**Subject: Vermont Yankee Nuclear Power Station
License No. DPR-28 (Docket No. 50-271)
Technical Specification Proposed Change No. 260
Intermediate Range Monitor Surveillance Test Frequencies**

Proposed Technical Specification Change No. 260

Intermediate Range Monitor Surveillance Test Frequencies

Marked-up Version of the Current Technical Specifications

TABLE 4.1.1

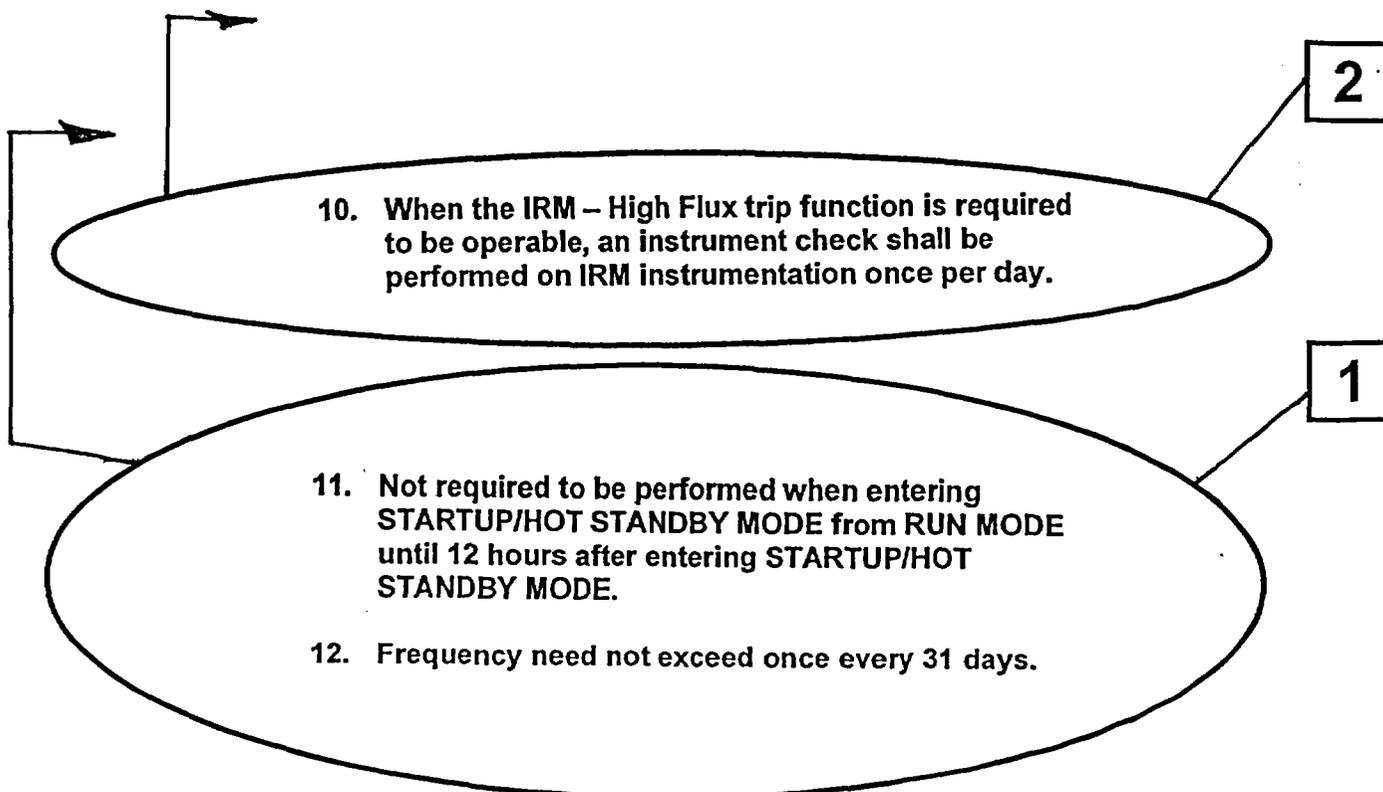
Change #	Current Technical Specification	Proposed Change
1	<p>Current Technical Specification (CTS) Table 4.1.1 provides functional test requirements for the Reactor Protection System (RPS) functions.</p> <p>The functional test frequency specified for each of the RPS Intermediate Range Monitor (IRM) functions is as follows:</p> <p><i>Before Each Startup & Weekly During Each Refueling⁽⁶⁾.</i></p> <p>Note 6 to Table 4.1.1 states:</p> <p><i>6. Frequency need not exceed weekly.</i></p>	<p>The surveillance test interval for the functional test, as applied to these functions, is being increased from weekly to once every 31 days, for a maximum interval of 39 days, including the 25% grace period allowed by CTS definition 1.0.Y, "Surveillance Frequency." The word "During" is provided, to the minimum frequency requirement and is applicable during startup as an additional restriction to ensure that the surveillance is maintained current when the unit is in startup.</p> <p>For the RPS IRM functions, the minimum frequency specified in Table 4.1.1 is changed to:</p> <p><i>Before and During Each Startup & Once Every 31 Days During Refueling⁽¹¹⁾⁽¹²⁾.</i></p> <p>New Note 11 is added to Table 4.1.1 and states:</p> <p><i>11. Not required to be performed when entering STARTUP/HOT STANDBY MODE from RUN MODE until 12 hours after entering STARTUP/HOT STANDBY MODE.</i></p> <p>New Note 12 is added to Table 4.1.1 and states:</p> <p><i>12. Frequency need not exceed once every 31 days.</i></p>

~~Before Each Startup & Weekly
During Refueling⁽⁶⁾~~
~~Before Each Startup & Weekly
During Refueling⁽⁶⁾~~

Before and During
Each Startup & Once
Every 31 Days During
Refueling^{(11) (12)}

10. When the IRM-High Flux trip function is required to be operable, an instrument check shall be performed on IRM instrumentation once per day.
11. Not required to be performed when entering STARTUP/HOT STANDBY MODE from RUN MODE until 12 hours after entering STARTUP/HOT STANDBY MODE.

12. Frequency need not exceed once every 31 days.

TABLE 4.1.2

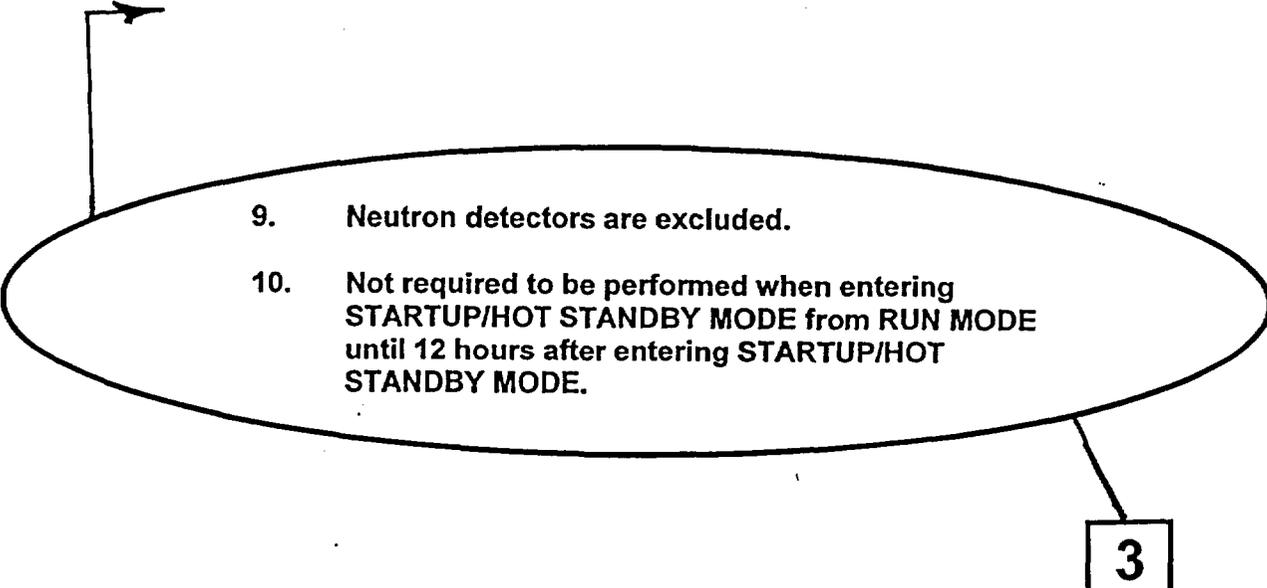
Change #	Current Technical Specification	Proposed Change
3	<p>CTS Table 4.1.2 provides calibration requirements for selected RPS functions. Currently, Table 4.1.2 does not include explicit calibration requirements for the RPS IRM – High Flux function.</p>	<p>CTS Table 4.1.2 and the associated Notes to Table 4.1.2 are revised to include calibration requirements for the RPS IRM – High Flux function.</p> <p>CTS Table 4.1.2 is revised to include the following as the first line:</p> <p>In the <u>Instrument Channel</u> column;</p> <p style="padding-left: 40px;"><i>High Flux IRM</i> <i>Output Signal (7) (9) (10)</i></p> <p>In the <u>Group</u>⁽¹⁾ column;</p> <p style="padding-left: 40px;">C</p> <p>In the <u>Calibration Standard</u>⁽⁴⁾ column;</p> <p style="padding-left: 40px;"><i>Standard Voltage Source</i></p> <p>In the <u>Minimum Frequency</u>⁽²⁾ column;</p> <p style="padding-left: 40px;"><i>Once/Operating Cycle</i></p> <p>CTS Table 4.1.2 Notes are revised to include new Notes 9 and 10:</p> <p style="padding-left: 40px;">9. <i>Neutron detectors are excluded.</i></p> <p style="padding-left: 40px;">10. <i>Not required to be performed when entering STARTUP/HOT STANDBY MODE from RUN mode until 12 hours after entering STARTUP/HOT STANDBY MODE.</i></p>

Main Steam Line Isolation Valve Closure	A	(6)	Refueling Outage
High Flux IRM Output Signal (7)(9)(10)	C	Standard Voltage Source	Once/Operating Cycle

9. Neutron detectors are excluded.

10. Not required to be performed when entering STARTUP/HOT STANDBY MODE from RUN MODE until 12 hours after entering STARTUP/HOT STANDBY MODE.
